Access Compliance Report Public Rights-of-Way (Curb Ramps)

Intersection ID: 29985 Main Street: NELAND_LN Cross Street: WINDING_RIVER_DR Location: S **Overall Compliance: No ADA ID: 4EEC75B5BCDA** Ramp Type: Perp Initial Pass/Fail: Fail **Severity Score:** 25

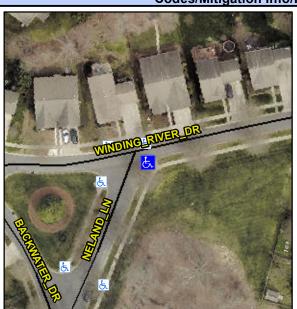
ossible Solutions:	<u>c</u>
Remove & Replace Entire Ramp.	
·	Υ
	N
	N
	N
	N
urveyor Notes:	N
N/A	N
	N
	N
	N
ROW/ADA:	N
Not Found, R304.2.2, R304.5.3	
	N
	N
	N

Field Measurements/Component Compliance								
Comp	oliance Description	Data	Comp	liance Description	Data			
N/A	Ramp Length (in)	71.0	No	Ramp Slope (%)	9.1			
Yes	Ramp Width (in)	48.0	No	Ramp XSlope (%)	5.3			
N/A	Flare Type LT	N/A	N/A	Flare Type RT	N/A			
N/A	Flare Slope LT (%)	N/A	N/A	Flare Slope RT (%)	N/A			
N/A	Flare Traversable LT?	N/A	N/A	Flare Traversable RT?	N/A			
N/A	Landing Length (in)	N/A	N/A	DWS Provided?	N/A			
N/A	Landing Width (in)	N/A	N/A	DWS Contrast?	N/A			
N/A	Landing Slope (%)	N/A	N/A	DWS Length (in)	N/A			
N/A	Landing X Slope (%)	N/A	N/A	DWS Full Width?	N/A			
N/A	Landing Curb? (Y/N)	N/A	N/A	DWS Offset (in)	N/A			
N/A	Shared Landing?	N/A						
N/A	Gutter Ponding?	N/A	N/A	Gutter Slope (%)	N/A			
N/A	Gutter Lip Ht (in)	N/A	N/A	Gutter X Slope (%)	N/A			
N/A	Painted X Walk1?	No	N/A	Painted X Walk2?	N/A			
	X Walk 1 Direction	To N		X Walk 2 Direction	N/A			
N/A	X Walk 1 Width (in)	N/A	N/A	X Walk 2 Width (in)	N/A
